Peer Review Comment Response

42 Mill Street, Westwood MA

Re: Peer Review Comment Response
 42 Mill Street, Westwood MA

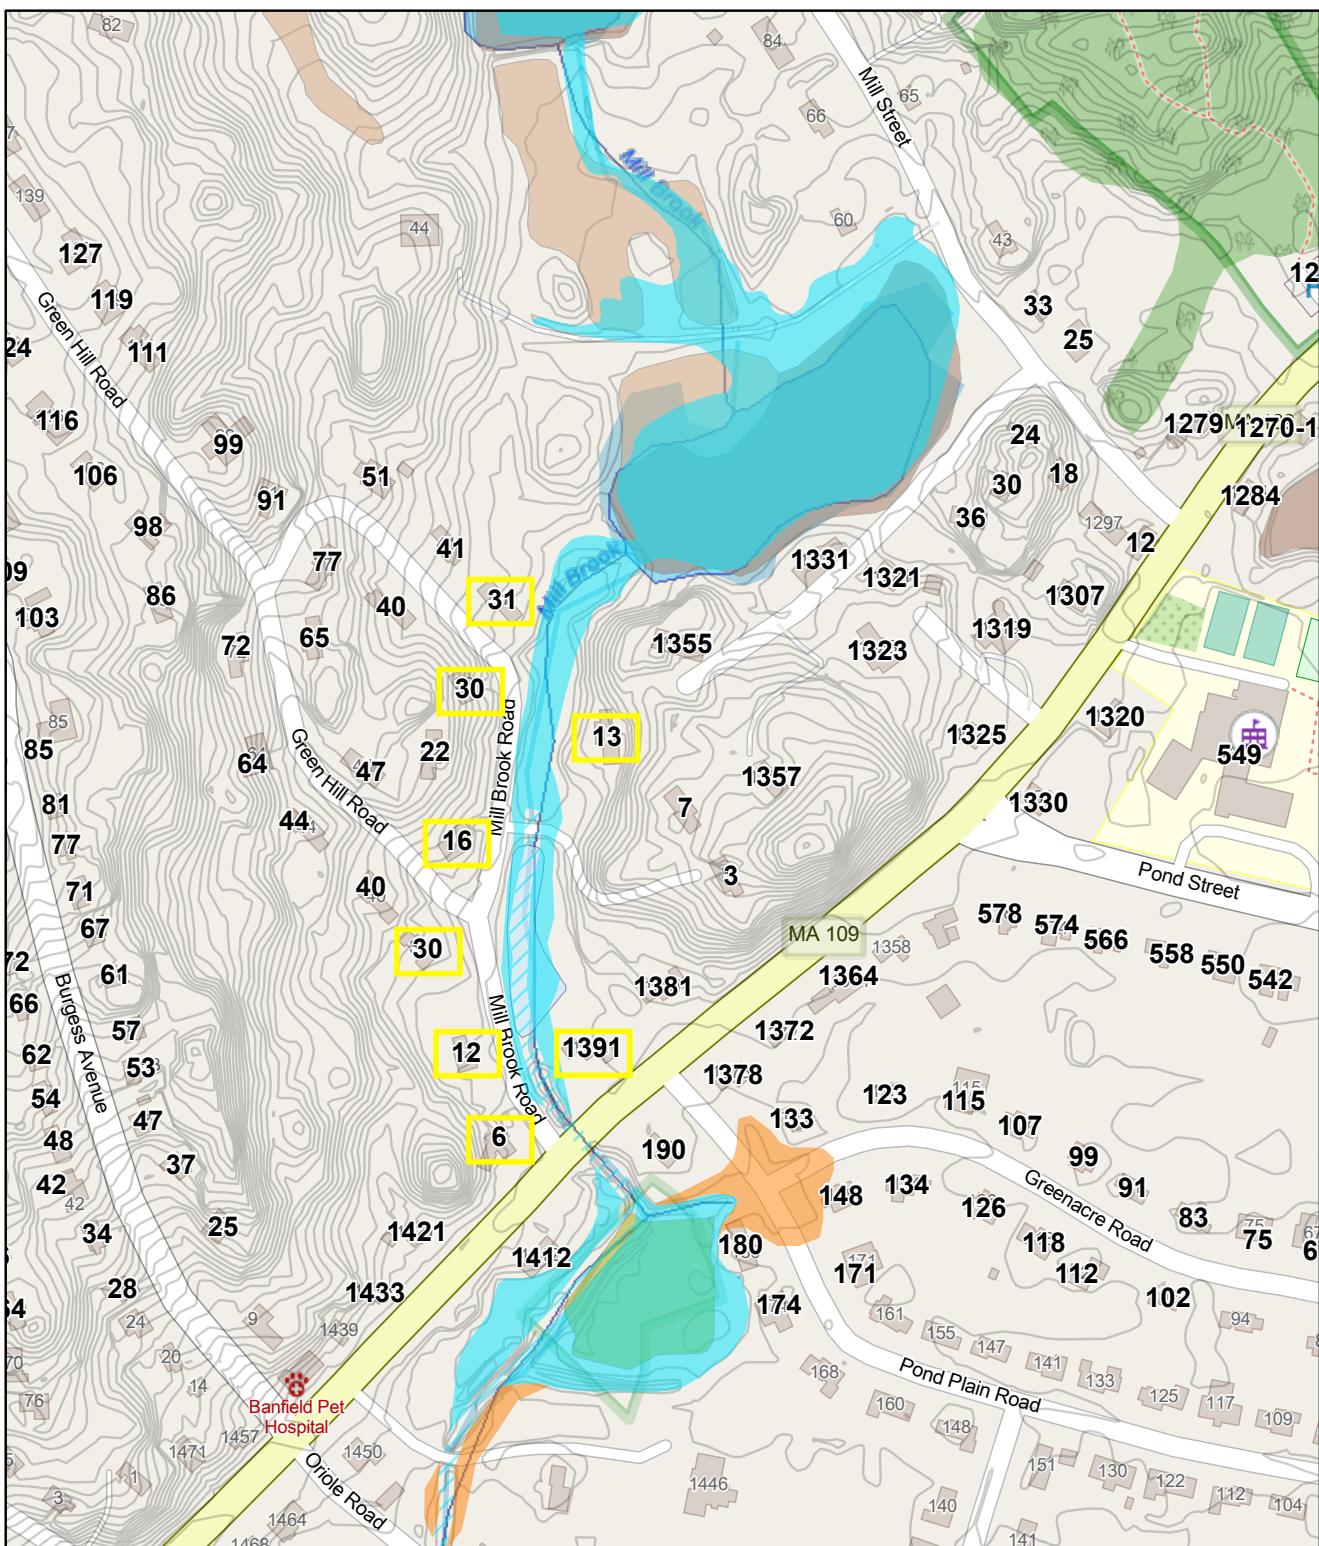
| Peer Review Comment | Goddard Response |
|---|---|
| <p><i>Engineer should provide calculations for spillway dimensions and what event it is sized to pass. At a minimum the spillway should be designed to pass the 100-year storm without overtopping the dam. Design should be by a PE with experience in dam design. Design should demonstrate that Dam Safety Regulations (302 CMR 10) are being met and that it would be classified as a low hazard dam regardless of whether it requires regulation by DCR in order to protect the Town from liability.</i></p> | <p>Calculations for spillway dimensions demonstrating its capability to pass the 100-year storm are attached to this document. Failure of the dam is likely to cause localized flooding, but is not expected to cause major property damage or loss of life, and therefore would be classified as a Low Hazard Dam.</p> |

Suppressed Sharp Crested Weir Equation: $Q=3.33BH^{3/2} *$

$$Q = 184 \text{ cfs} = 3.33 \times 14' \times (2.5')^{1.5}$$

Published FEMA FIS discharge just downstream of the dam for the 100-yr (1% chance) event = 172 cfs.

Conclusion is that the weir capacity can handle the 100-yr flow. Further support of this is the FEMA Firmette Flood Map, which shows consistency with observed elevations.

Abutter's Downstream Baker's Pond

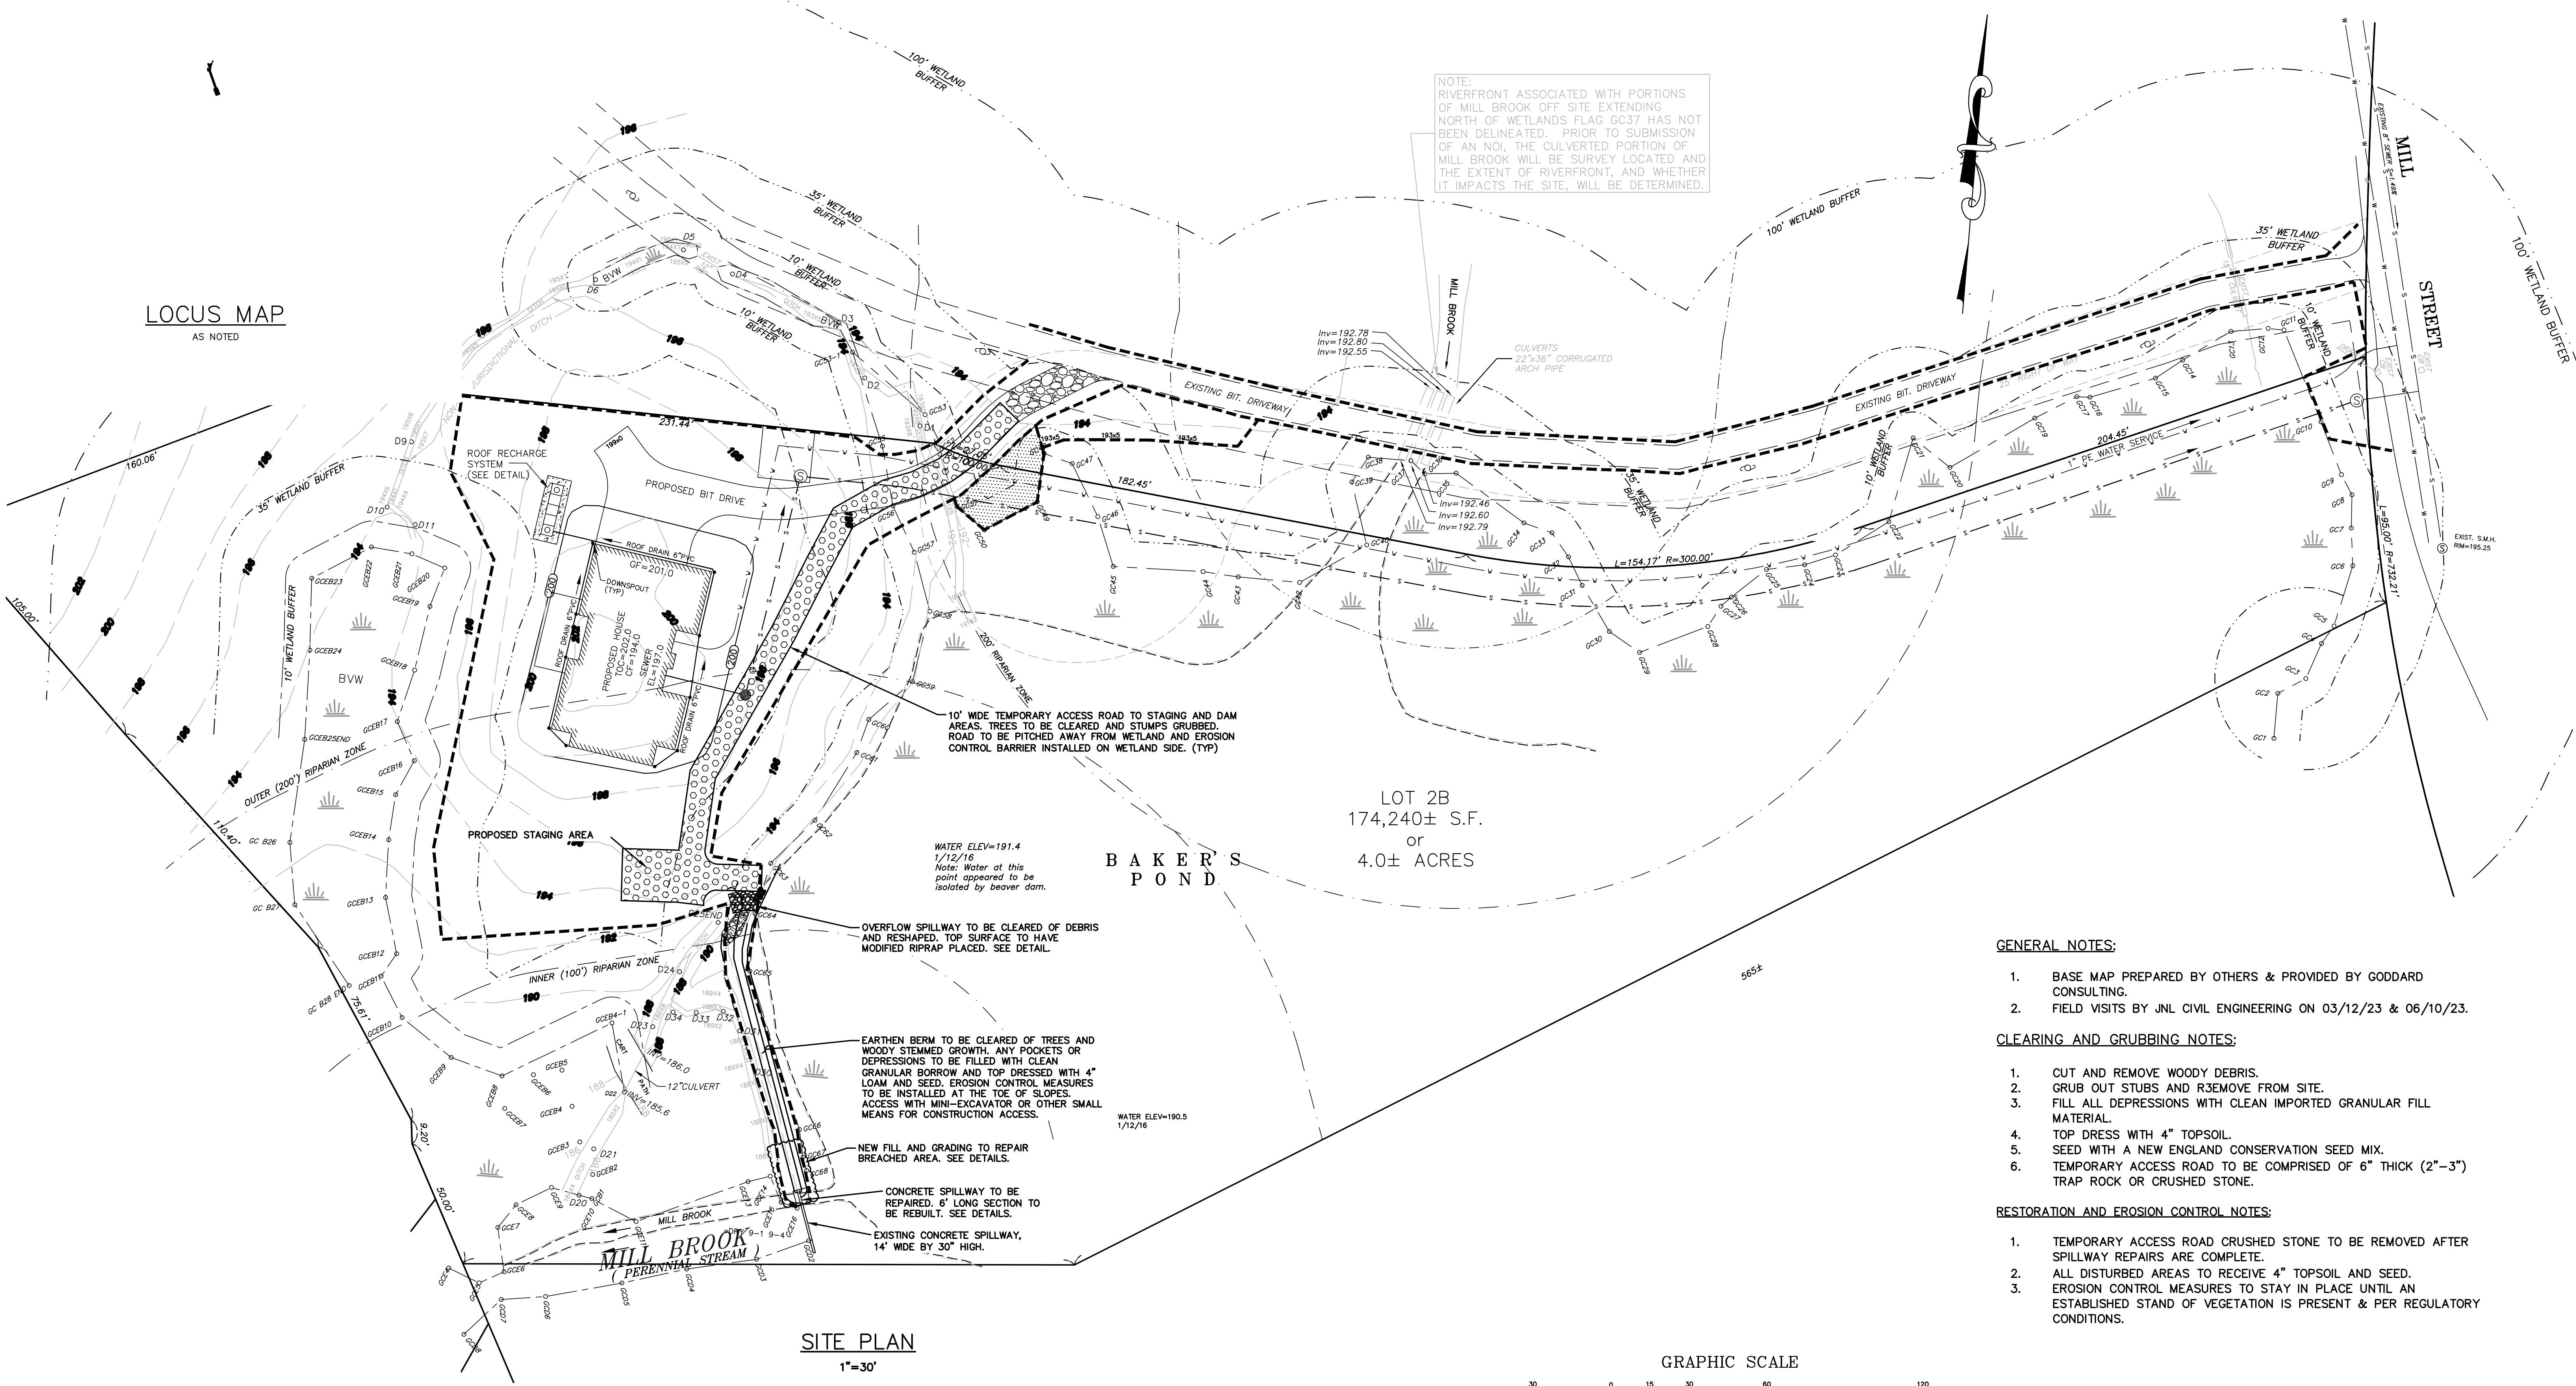
| Peer Review Comment | Goddard Response |
|---|---|
| <p><i>Engineer needs to provide more details (dimension & sizes) to better understand the existing and proposed condition of the dam & pond. Also provide details on who is downstream and would be impacted if dam fails.</i></p> | <p>Additional details, including measurements and sizes, have been added to the site plans (titled Baker's Pond Spillway Repair Plans, last revised 9/5/23).</p> <p>Abutters impacted by a dam failure include those at 6, 12, 13, 16, 30 and 31 Mill Brook Road, and 1391 High Street. A map of impacted abutters is attached to this document.</p> |

BAKER'S POND
SPILLWAY REPAIR DETAILS

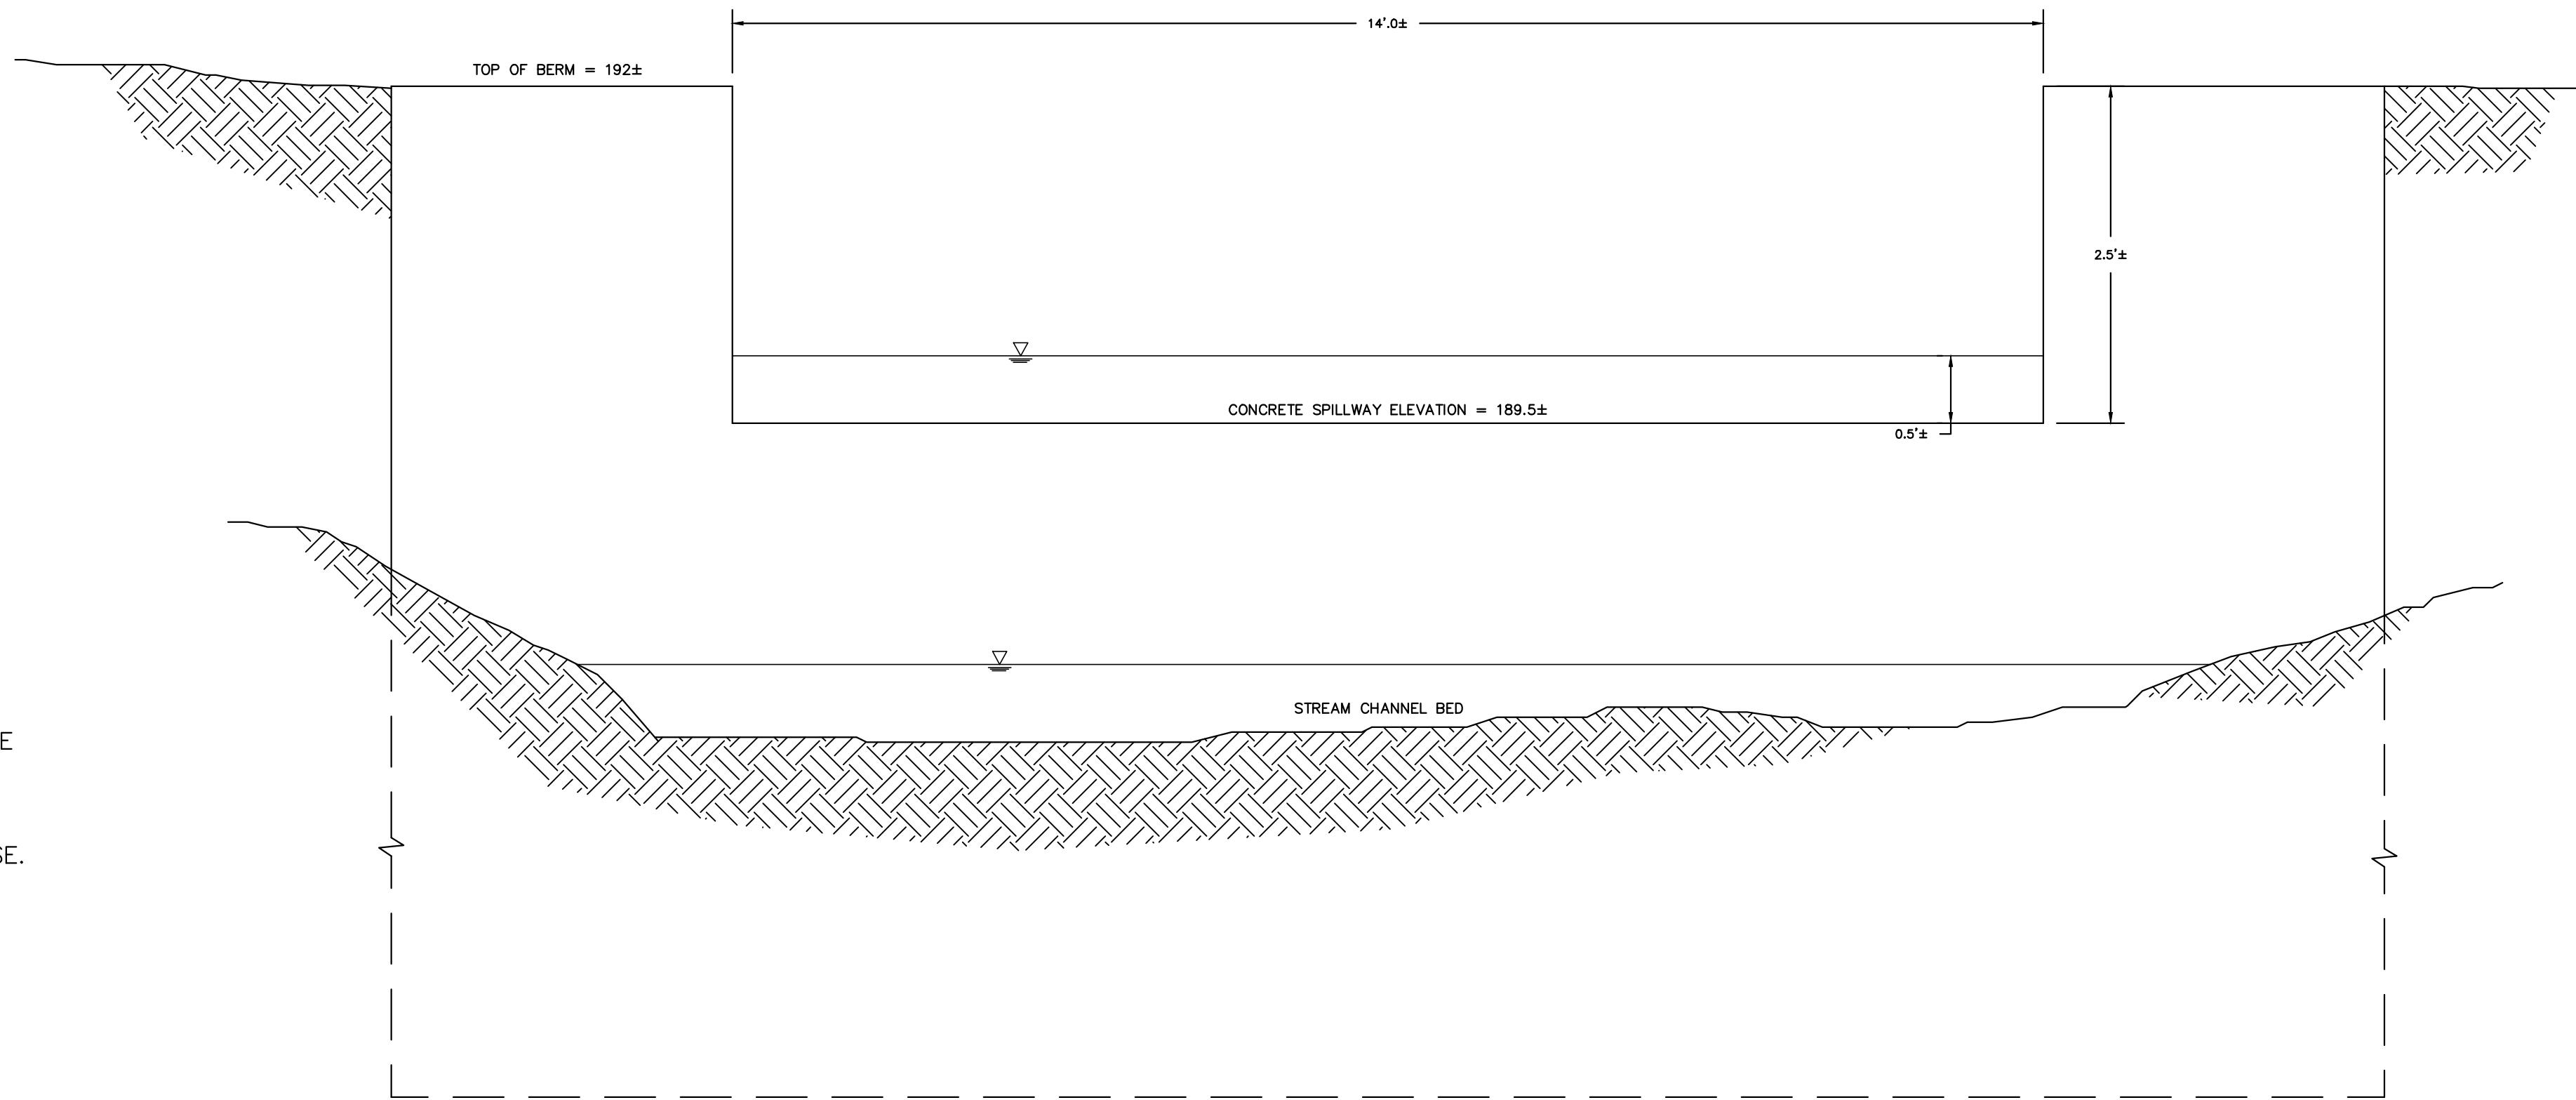
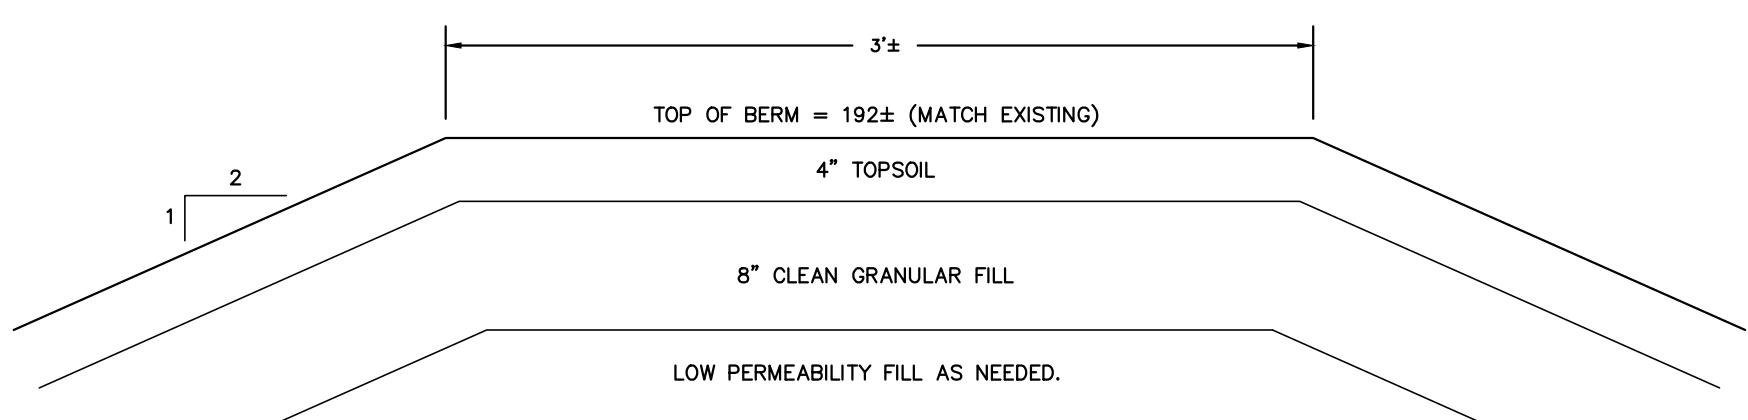
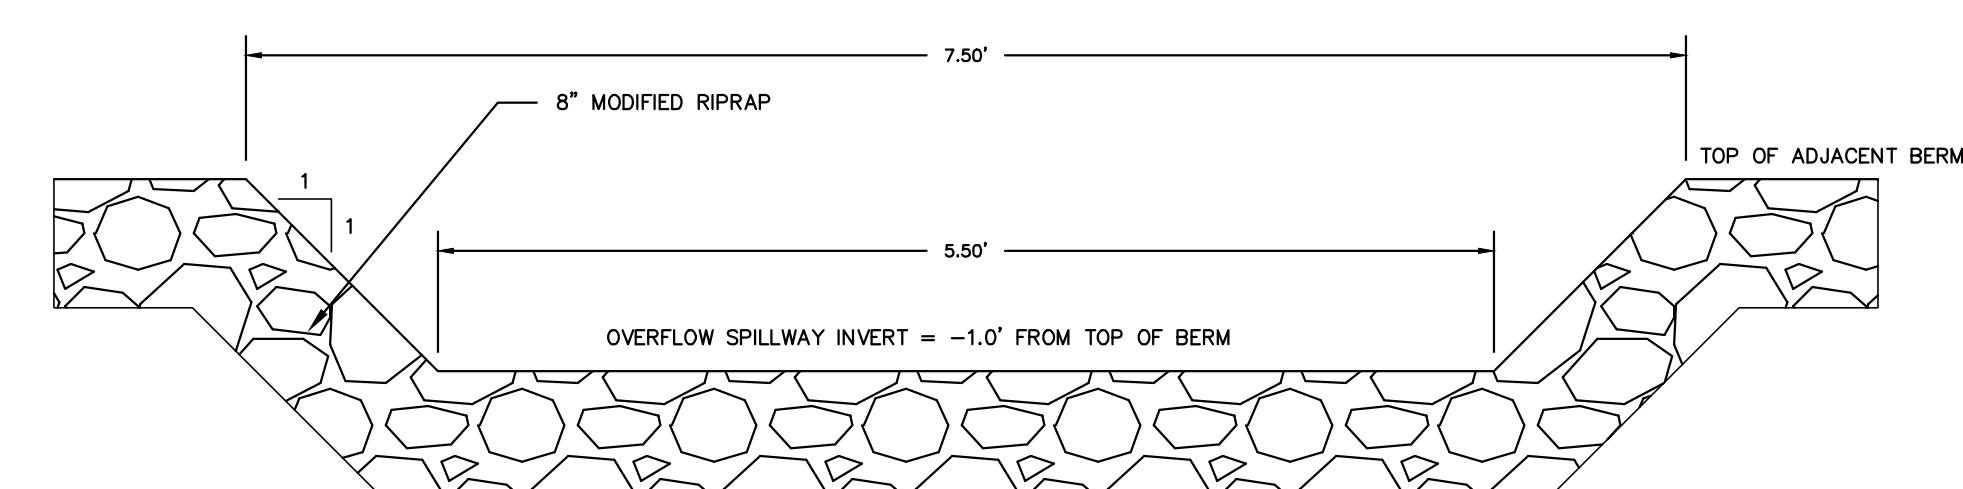
| Peer Review Comment | Goddard Response |
|---|---|
| <p><i>This dam does not show up in the state database however regulation is based on size. Dam Safety Regulations 302CMR10 (<15ac feet or less than 6' in dam height is not subject to regulation) however the detail on this plan shows that it exceeds 6' based on proposed spillway dimension. If it is existing and being repaired or designed under the threshold then may not be regulated however the new homeowner and town will be taking on some liability either way.</i></p> | <p>Dam Safety Regulations 302 CMR 10.03 defines the height of a dam as “the vertical distance from the elevation of the dam crest to the lowest point of natural ground, including any stream channel, along the downstream toe of the dam.”</p> <p>The vertical distance between the elevation of the dam crest and the stream channel bed is 4.6ft, less than the 6' height required to be regulated.</p> <p>The applicant acknowledges the liability associated with owning a dam on their property.</p> |
